CITY OF SAN ANTONIO

Re: **Huebner Square Townhomes** **MDP # 006-06**

The City Staff Development Review Committee has reviewed the Huebner Square Townhomes Development Plan, **M.D.P. # 006-06**. Enclosed, please find a signed copy for your files. Your plan was accepted however please note the following:

HUEBNER SQUARE TOWNHOMES, P.U.D.
MASTER DEVELOPMENT PLAN

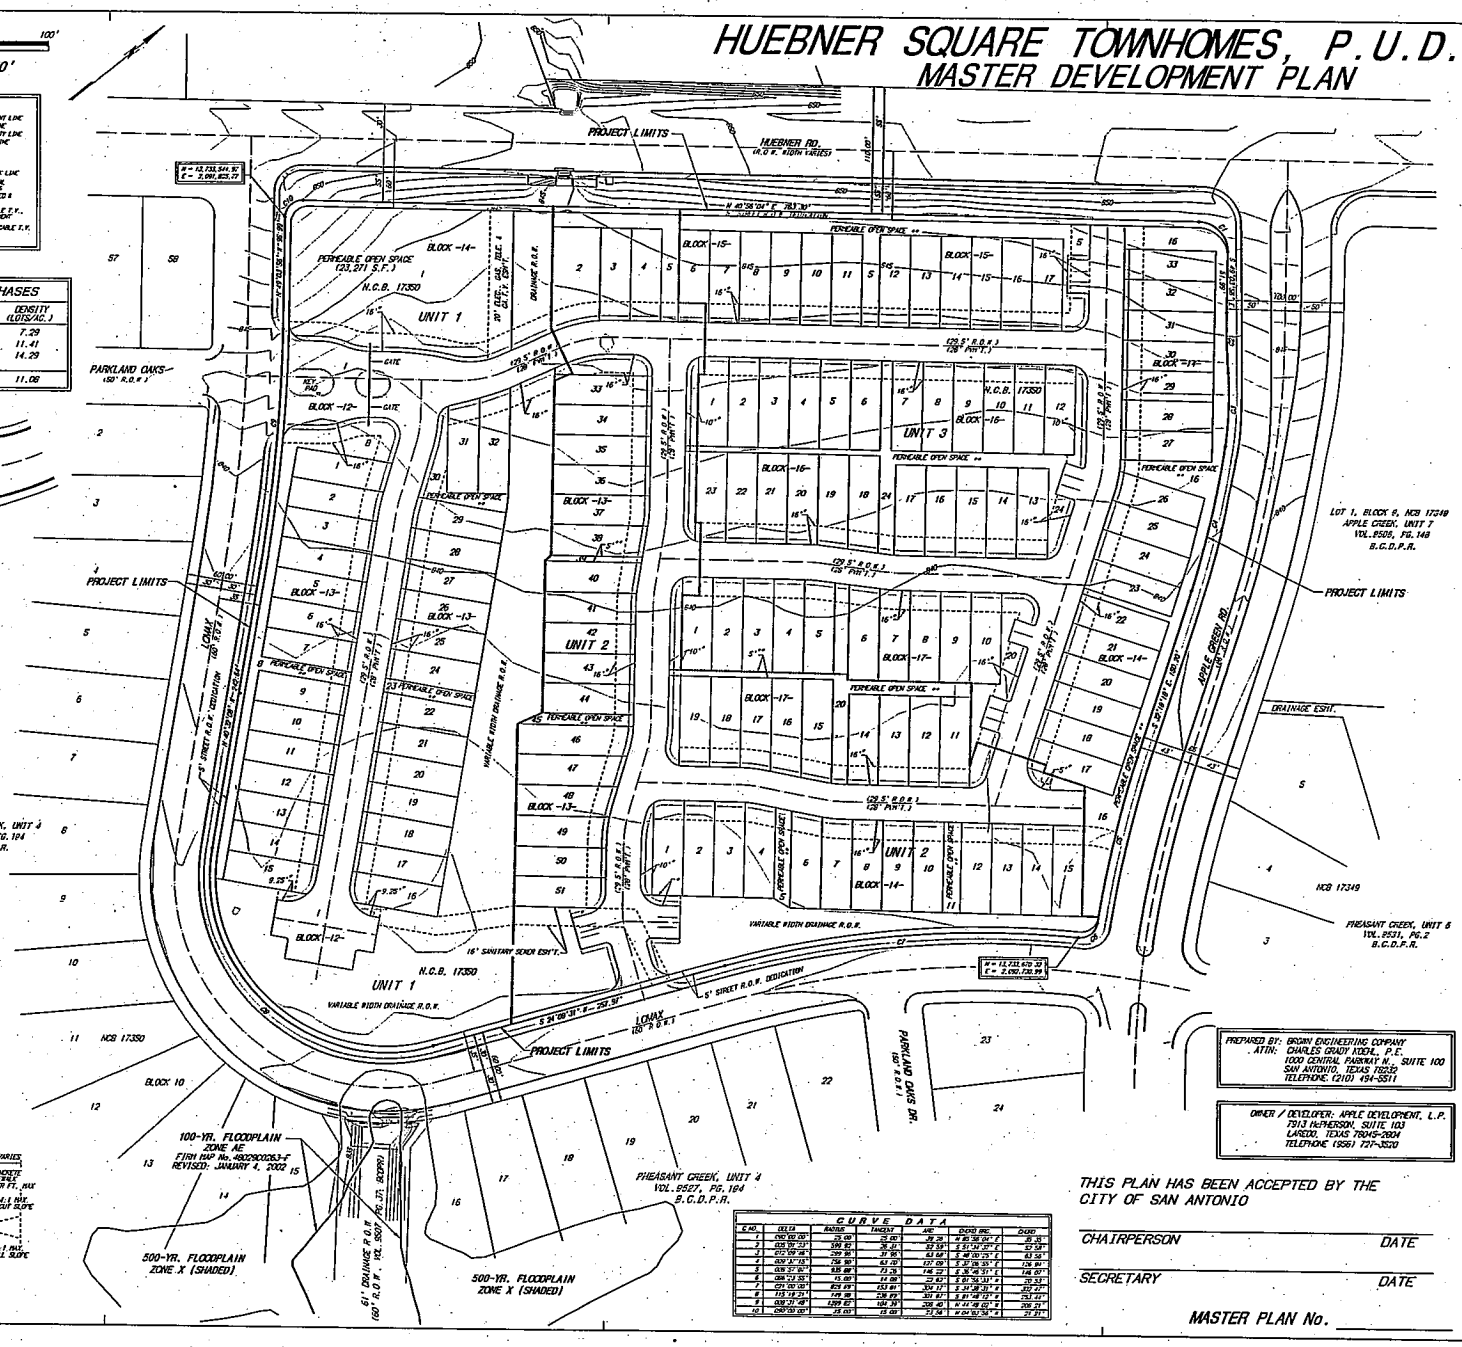
- In consideration of public safety and convenience, excessive grades by reason of topography should be avoided in street layouts and arrangements.

- It will be expected that you will plat all of the property depicted in your Master Development Plan (M.D.P.) to include floodplains, drainage areas and open space.

- **Parks and Recreation:** Huebner Square Townhomes is a proposed subdivision with 133 multi-family residential units. UDC Section 35-503, Table 503-1 states that single-family development is required to provide 1 acre of park/open space per every 114 dwelling units. The requirement for this development is 1.2 acres. This development provides 0.5 acres of park to include an Open Play Area for 1.0 acre credit and a Picnic Area for 0.25 acres credit.

- The parkland provided is dedicated to the Home Owners Association.
- A Provision and Maintenance Plan is provided to this department at the time of platting.
- Parkland dedication must be platted by the second phase of development.
- Amenities provided follow design criteria set forth in Table 503-4 in order to gain parkland credit.

- All access roadways shall provide clear sight distance on all existing and proposed roadways in order to provide adequate obstruction free viewing distances for approaching traffic. All signage, landscaping, and improvements shall be selected and located so as to not block these clear sight distance areas.
- All commercial driveways for this project shall comply with UDC 35-506, (r) Access and Driveways.
- Sidewalks along all interior and exterior roadways are to be installed in accordance with UDC 35-506(q).
- Hammerhead turnaround at the end of streets will be required to meet the International Fire Code or the City of San Antonio requirements for fire truck turnaround.
- Please be aware that by UDC requirements there is no on-street parking allowed on 27-foot wide roads.
